Access Compliance Report

Public Rights-of-Way

(Curb Ramps)

Intersection ID: 11157	Main Street: N_IRWIN_AV	Cross Street: W_6TH_ST	Location: W
ADA ID: 71C89F10C8AF	Ramp Type: Directional1	Initial Pass/Fail: Pass	Overall Compliance: No
		Severity Score: 0.25

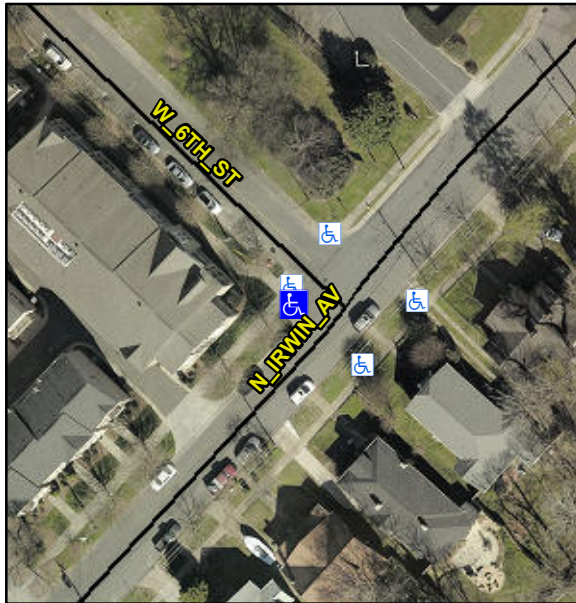
Compliance	Description	Data	Compliance	Description	Data
N/A	Ramp Length (in)	62.0	Yes	Grade Break?	Yes
Yes	Ramp Width (in)	72.0	Yes	Grade Break Slope (%)	3.2
Yes	Ramp Slope (%)	1.2	No	Grade Break XSlope (%)	3.4
No	Ramp XSlope (%)	2.5			
N/A	Flare Type LT	N/A	Yes	Flare Type RT	N/A
N/A	Flare Slope LT (%)	6.6	N/A	Flare Slope RT (%)	N/A
N/A	Flare Traversable LT?	No	N/A	Flare Traversable RT?	No
Yes	Landing Length (in)	71.0	Yes	DWS Provided?	Yes
Yes	Landing Width (in)	71.0	Yes	DWS Contrast?	Yes
Yes	Landing Slope (%)	0.9	Yes	DWS Length (in)	24.5
No	Landing X Slope (%)	2.3	Yes	DWS Full Width?	Yes
N/A	Landing Curb? (Y/N)	No	Yes	DWS Offset LT (in)	47.0
N/A	Shared Landing?	Yes	Yes	DWS Offset RT (in)	1.0
Yes	Gutter Ponding?	No	Yes	Gutter Slope (%)	4.5
Yes	Gutter Lip Ht (in)	0.0	No	Gutter X Slope (%)	4.1
N/A	Painted X Walk1?	No		Road Slope (%)	3.1
	X Walk 1 Direction	To SE		Road X Slope (%)	1.4
	X Walk 1 Width (in)	N/A		Clear Space?	Yes

X Walk 1 Slope (%)	3.1	N/A	Clear Space to XWalk (in)	N/A
	X Walk 1 X Slope (%)	1.4	Yes	Storm Grate/Utility Hazard?	No
N/A	Ramp inside XWalk1?	N/A		Storm Grate/Utility Type	
Yes	Any Obstructions?	No			N/A
	Obstruction Type		Yes	Surface Condition? (G/P)	Good
			N/A	Curb Slope (%)	19.2

**Remove & Replace Entire Ramp.
Remove & Replace Gutter.**

R304.5.3
